RESPONSE TO REQUEST FOR ADDITIONAL INFORMATION

APR1400 Design Certification

RAI No.: 323-8281
SRP Section: 7.3
Application Section: 07.03 – Engineered Safety Features Systems
Date of RAI Issue: 11/30/2015

Question No. 07.03-14

Figure 7.3-1 Simplified Functional Diagram of the ESF-CCS

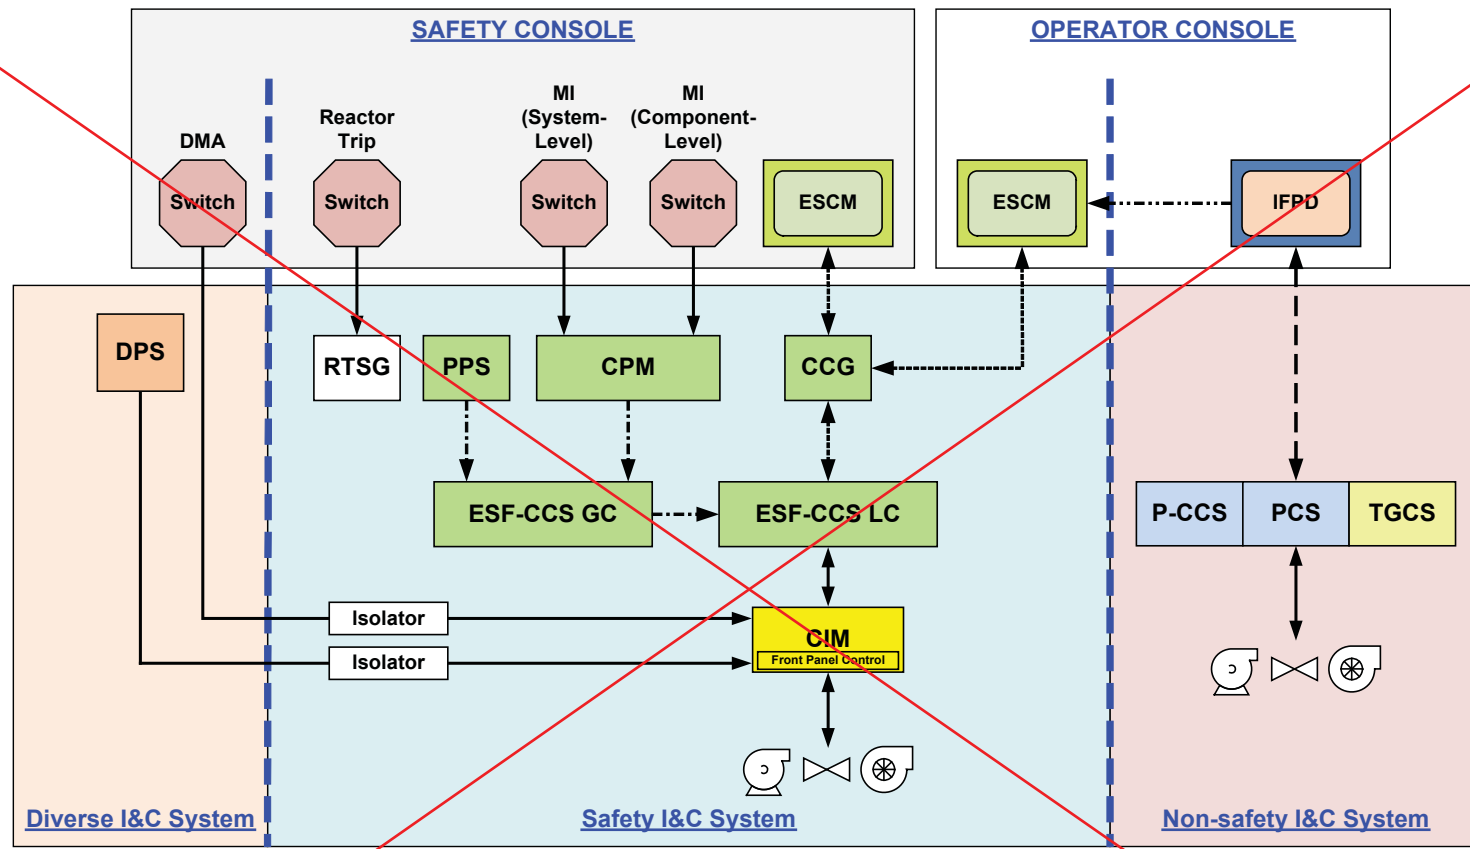
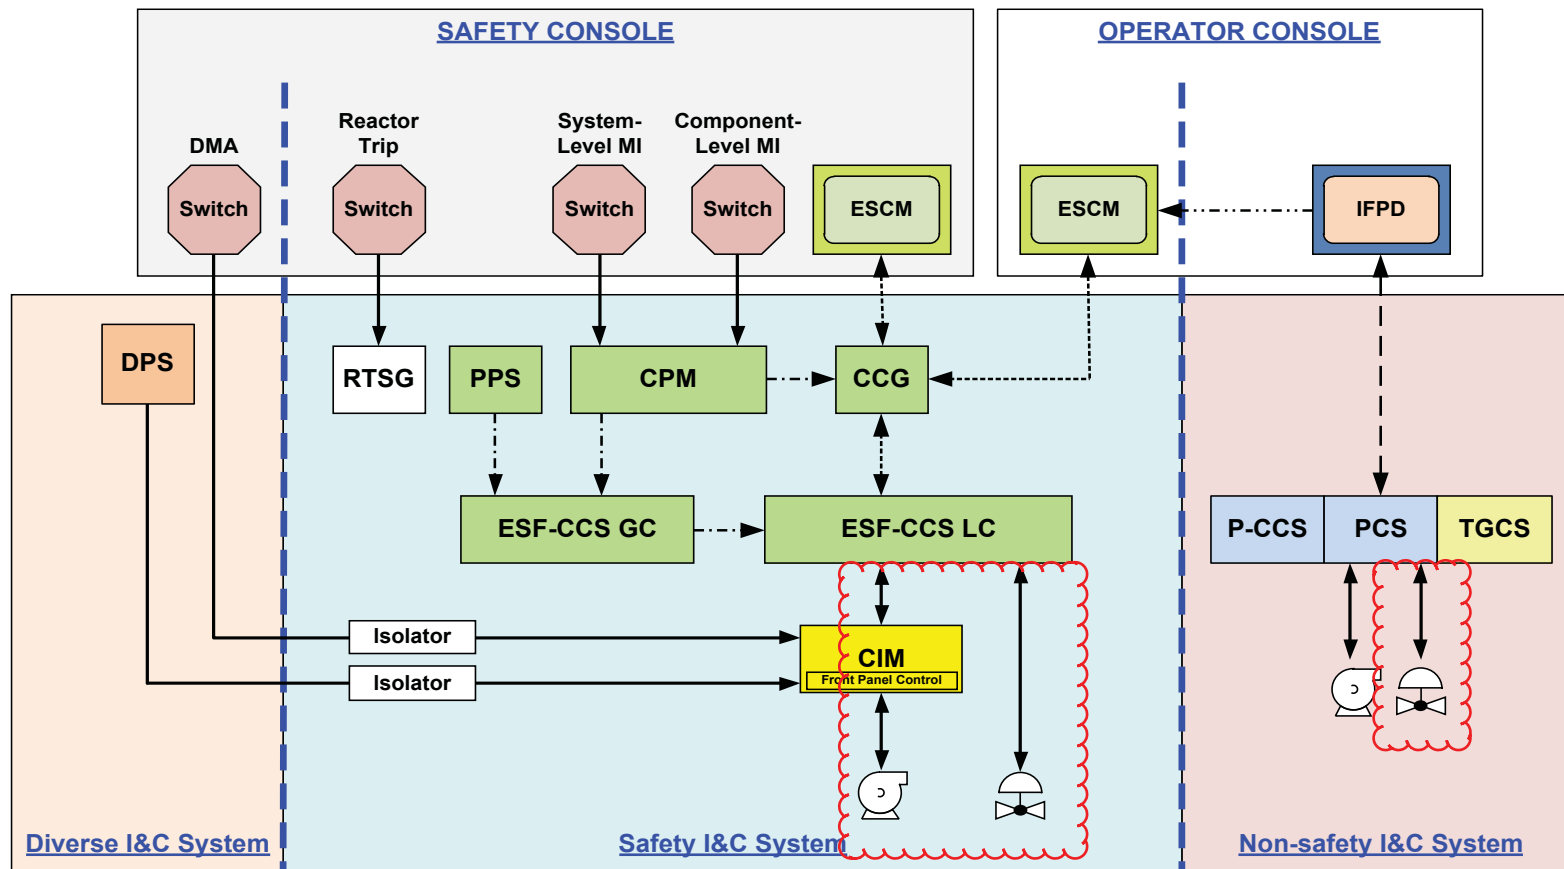
Figure 7.3-1, “Simplified Functional Diagram of the ESF-CCS,” in APR1400 FSAR Tier 2, Section 7.3, and Figure 4-13, “ESF-CCS Functional Configuration,” in Technical Report APR1400-Z-J-NR-14001-P, Rev. 0, “Safety I&C System,” illustrate the CIM being used to actuate all ESF components without differentiation between on-off and modulating ESF components. Figure 5.3-1, “Priority Logic Configuration in the CIM for the APR1400,” of Technical Report APR1400-E-J-NR-14001-P, Rev. 0, “Component Interface Module,” shows discrete inputs only to the priority logic section of the CIM for the ESF components. In the APR1400 application there is lack of design information on how safety-related control functions are implemented in the ESF-CCS system for ESF modulating components. Provide a clear description on how modulating control functions for certain ESF components are accomplished and update the technical report and FSAR figures and descriptions accordingly.

The ESCM sends manual operator demands such as auto/manual mode change, setpoint value in auto mode, and output value in manual mode, to the ESF-CCS LC through the CCG, and the ESF-CCS LC sends the actuator demand output. The component interface module (CIM) is bypassed.

Section 7.3.1 and Figure 7.3-1 of APR1400 DCD Tier 2 will be revised to present how safety-related control functions are implemented in the ESF-CCS system for ESF modulating components, as indicated in the attachment associated with this response.

For modulating control in the ESF-CCS, the sensors and actuators for modulating control are directly interfaced to the analog input module and the analog output module in the ESF-CCS loop controller (LC). Any non-discrete components which require modulation are controlled via the analog output module in the ESF-CCS LC. The component interface module (CIM) is bypassed.

Figure 7.3-16 CLD for a Throttling Motor-Operated Valve

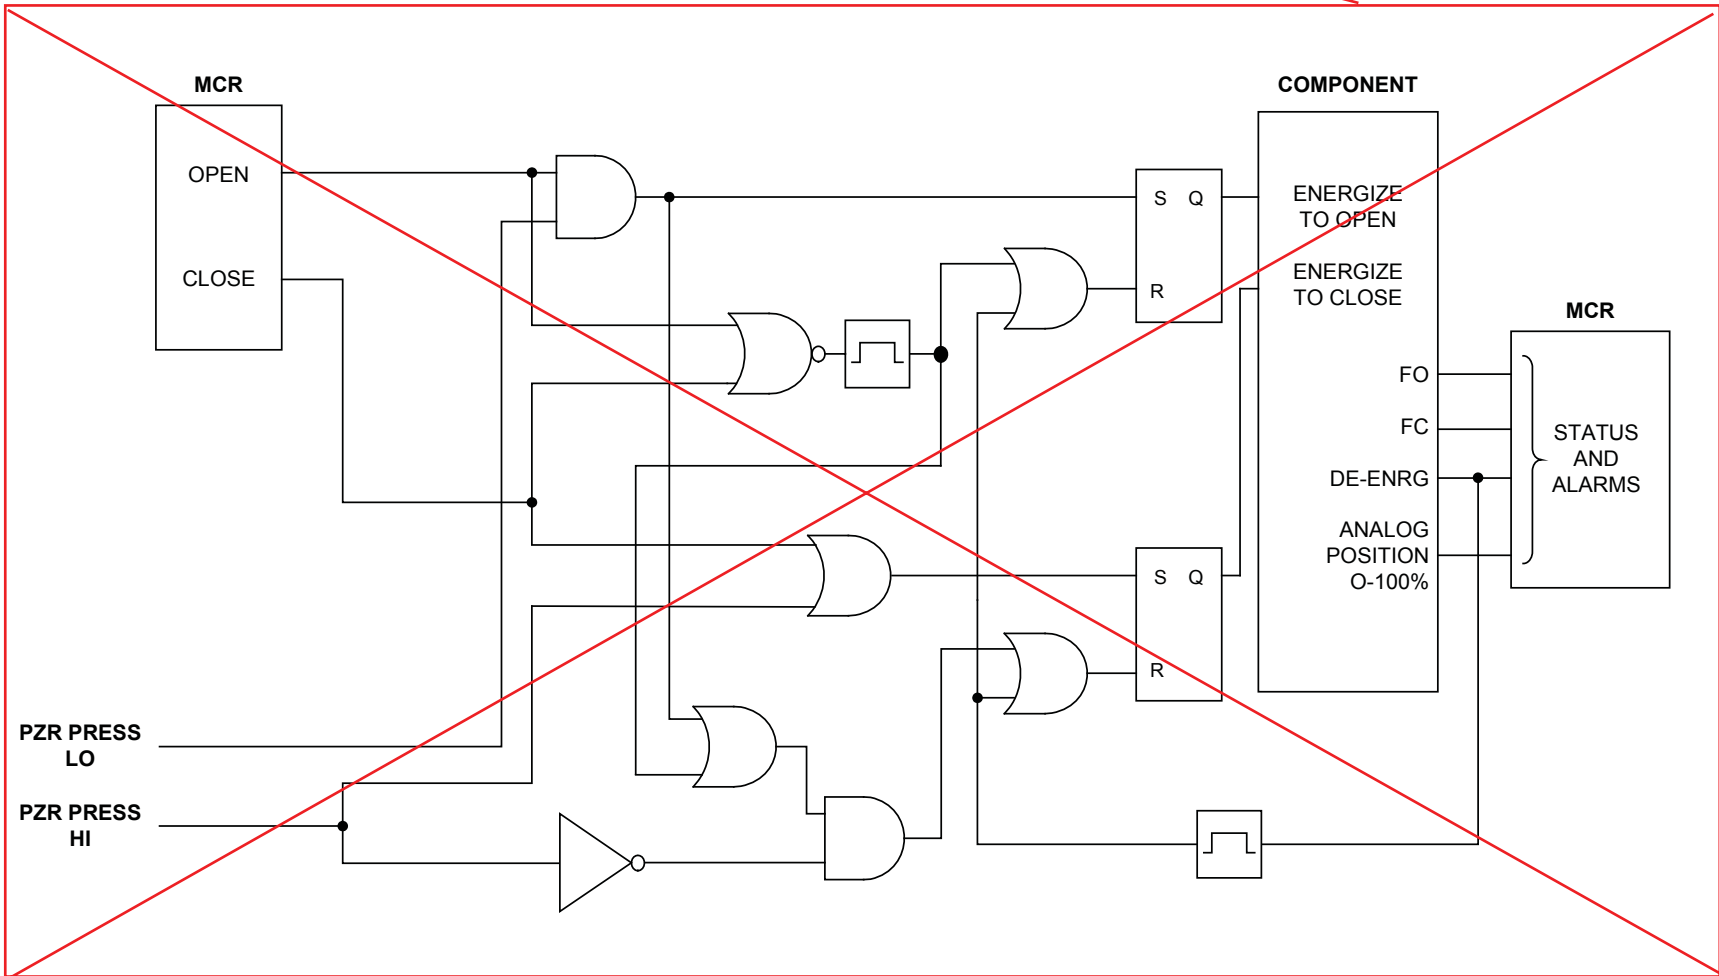
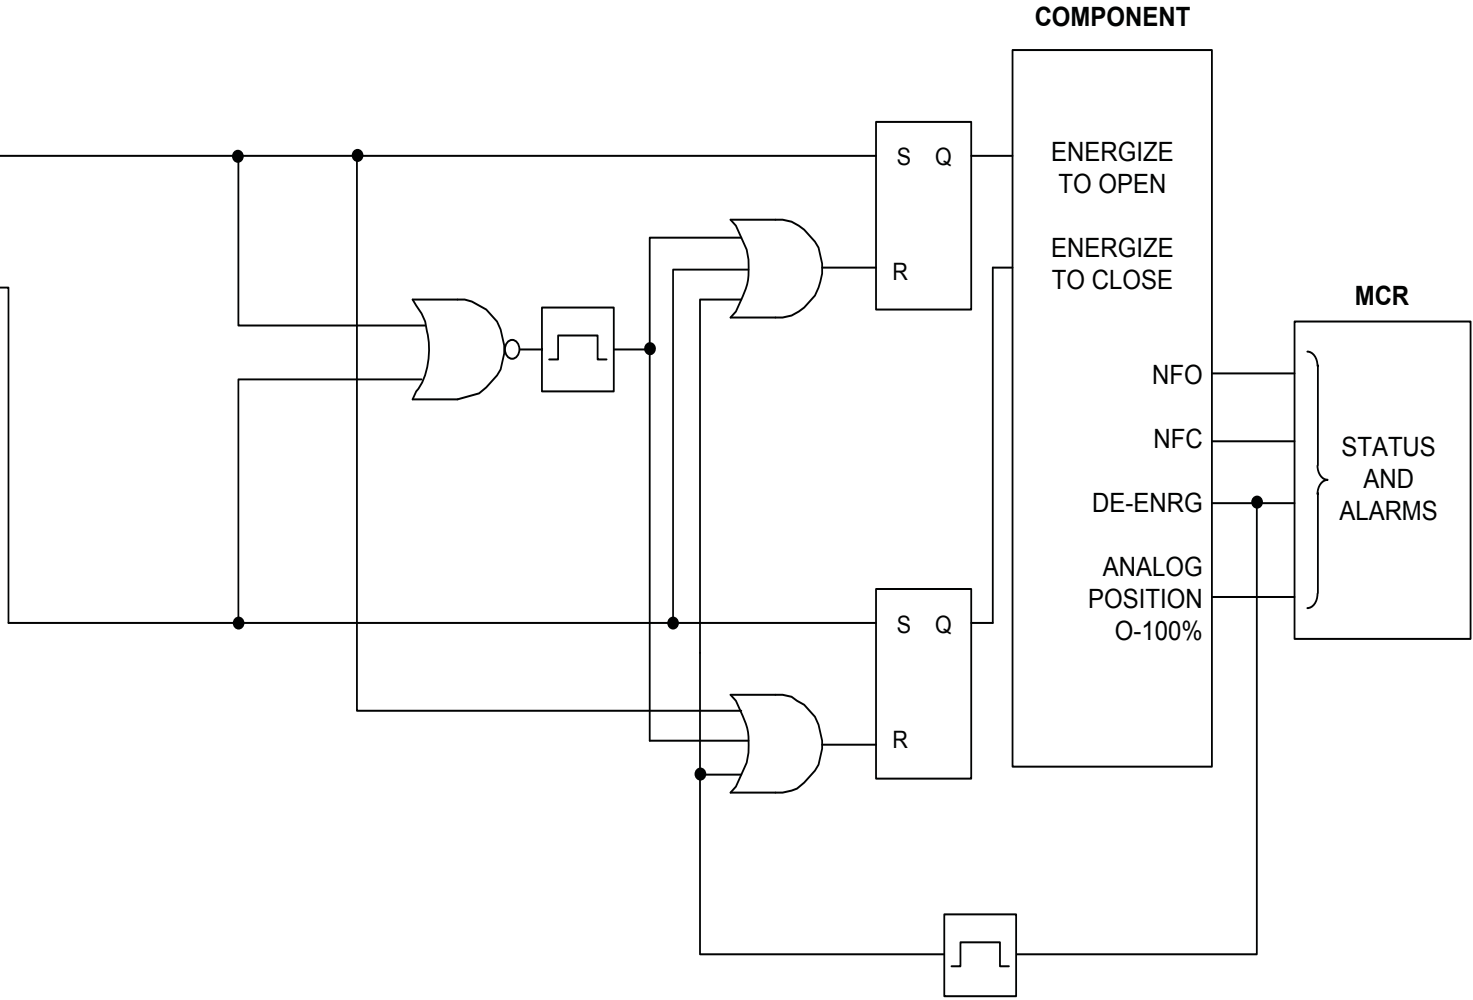
Figure 4-15 in Technical Report APR1400-Z-J-NR-14001-P, Rev. 0, "Safety I&C System", shows the simplified component control logic for ESF components. However, there is lack of definition or descriptive information in the APR1400 application for some logic inputs showing in the above diagram, such as process control (auto start), auxiliary stop, etc. Provide definition and functional description of logic inputs shown in Figure 4-15 which are not included in the application. Section 7.3.1.4 and its related component logic diagrams (CLD) in Figures 7.3-12 to 7.3-20 of APR1400 FSAR Tier 2 show the actuation logic for each type of ESF components. But, there is lack of design information on what relationship exists between those CLD figures and Figure 4-15 in the above Technical Report. Describe how each specific type of component logic diagram given in Section 7.3.1.4 of APR1400 FSAR Tier 2 is to be applied together with Figure 4.15 in the Safety I&C Technical Report.

The relationships between Figures 7.3-12 to 7.3-18, and 7.3-20 of DCD Tier 2 and Figure 4-15 of the Safety I&C System TeR, APR1400-Z-J-NR-14001-NP, Rev.0 will be provided, as indicated in the attachment associated with this response. DCD Tier 2, Figure 7.3-19 has no relationship to Figure 4-15 of the Safety I&C System TeR.

Figure 7.3-16 of DCD Tier 2 will be revised, as indicated in the attachment associated with this response.

OPEN (ESCM) or
OPEN (MI SWITCHES)

CLOSE (ESCM) or
CLOSE (MI SWITCHES)
